Issue to resolve

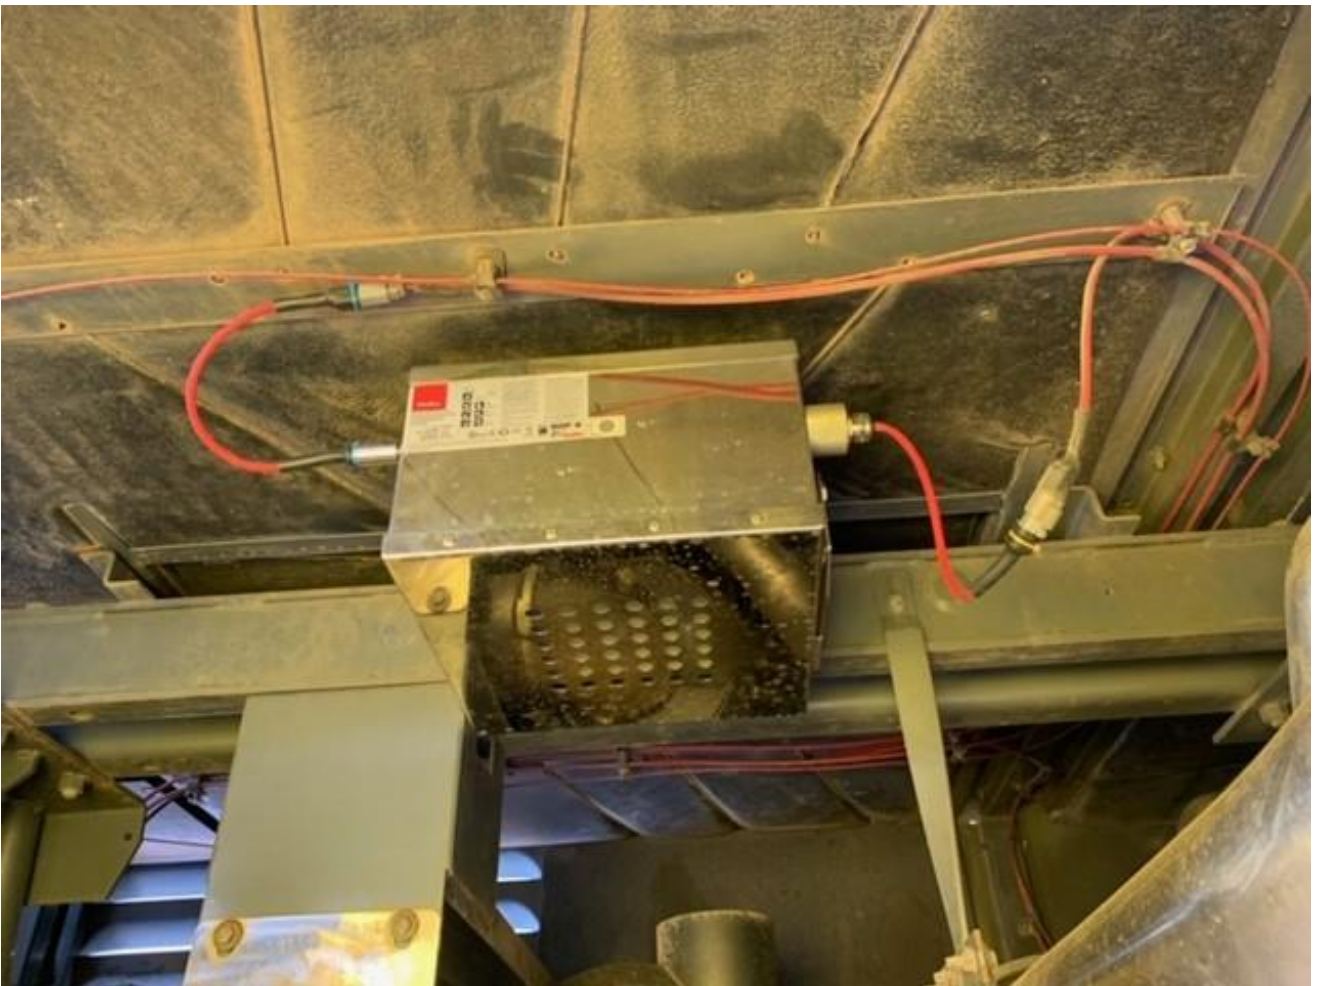
- Instal DUST COVER on FirePro Unit
- Replace Linear Heat Detection Cable with DP Version
